2 **REVISED PER ADDENDUM No. 2 DATED MARCH 21, 2013**

BRIDGE NO. 24-0121
POST MILE L6.98

THREE MILE SLOUGH
GUSSET PLATE DETAILS

THREE MILE SLOUGH
CONTROL HOUSE
ROOF PLAN AND DETAILS

GUSSET PLATE DETAIL

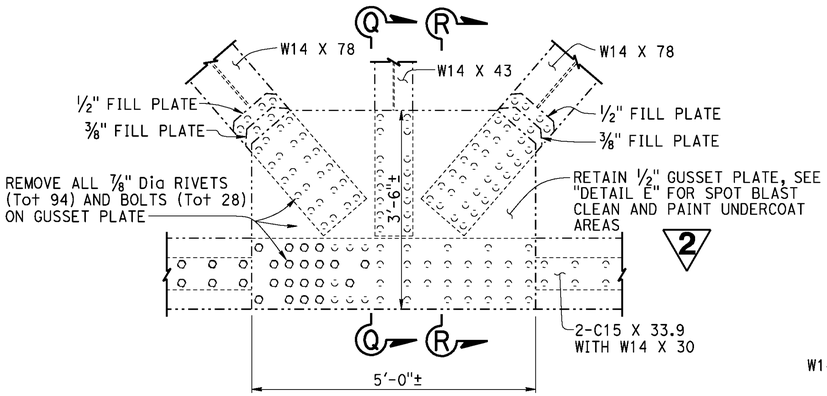
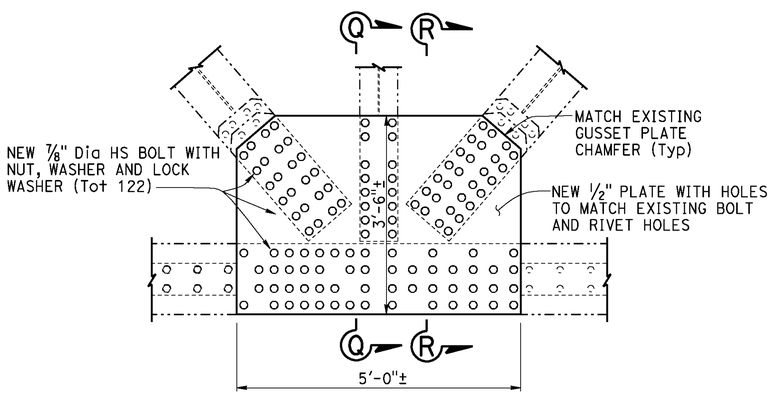
2 (NOTE: Paint New Structural Steel)

2 HIP DETAIL
SCALE 3" = 1'-0"

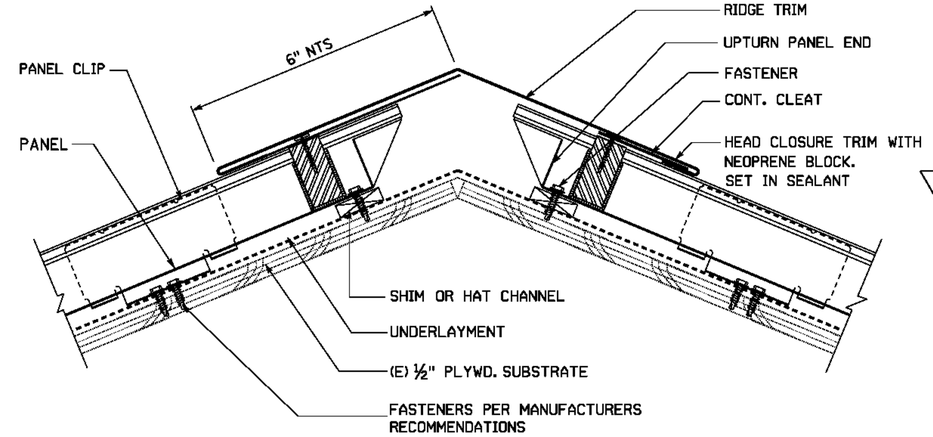
2 REVISED PER ADDENDUM No. 2 DATED MARCH 21, 2013
